Name of Proposed Development Harlan Park Phase Two

HARLAN PARK - PHASE TWO

Agenda Item: **P&Z 94-36-FP** - Discuss and Consider Approval of a Request from HOLMC, Inc., for a final plat of Harlan Park Phase II, a 10.319 Acre Tract of Land Located West of SH 205 and East of Holden Drive.

TO: Dub Douphrate, P.E.
FROM: Dan C. Boutwell, AICP
SUBJECT: PZ 94-36-FP (Harlan Park - Phase Two)
DATE: November 23, 1994

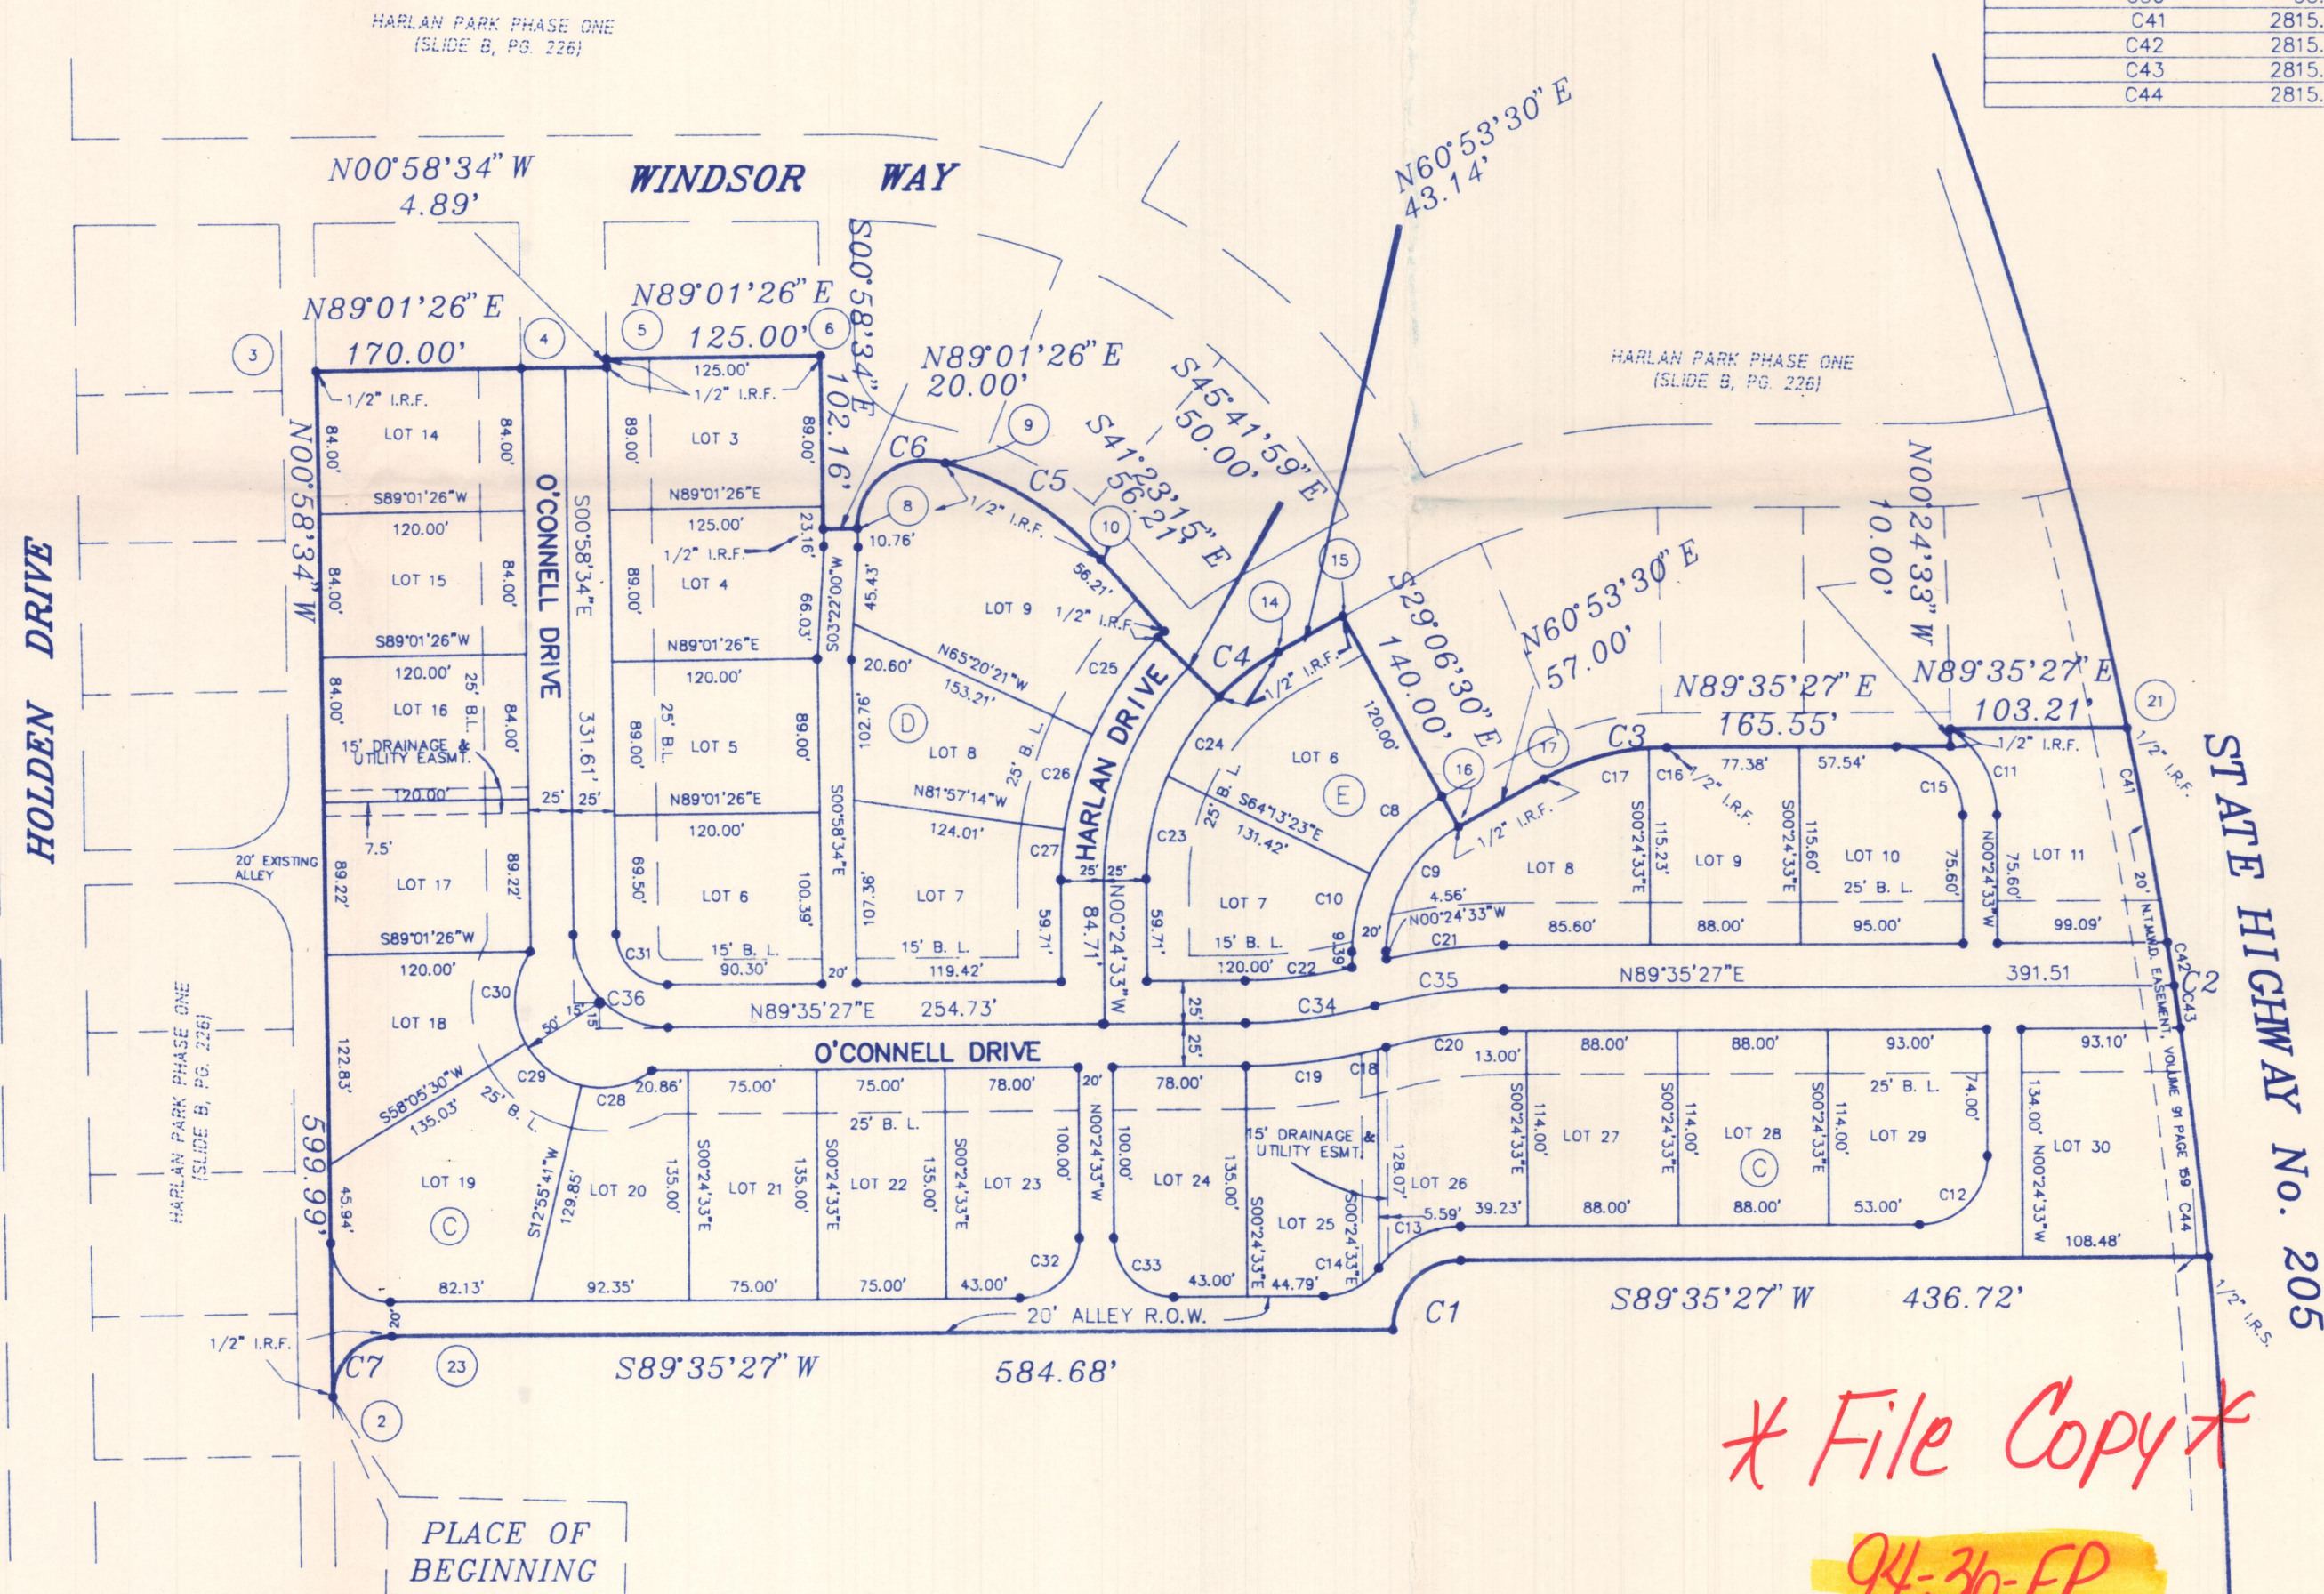
Recommendation: The Commission recommends approval of the final plat provided: 1) the location map is corrected to reflect the revised lot layout submitted herein; and 2) TxDOT approves the proximity of the proposed drive approach onto SH 205 in relation to the existing drive approach for Harlan Park Phase I. Staff anticipates a response from TxDOT prior to Monday night's Council meeting.

1. The legal description in the dedication statement does not match the drawing. This must be corrected.
2. The applicant must indicate the adjacent property owners to the south of this site.
3. The plat must be labeled as a Final Plat.
4. All required easements must be indicate on the final plat.
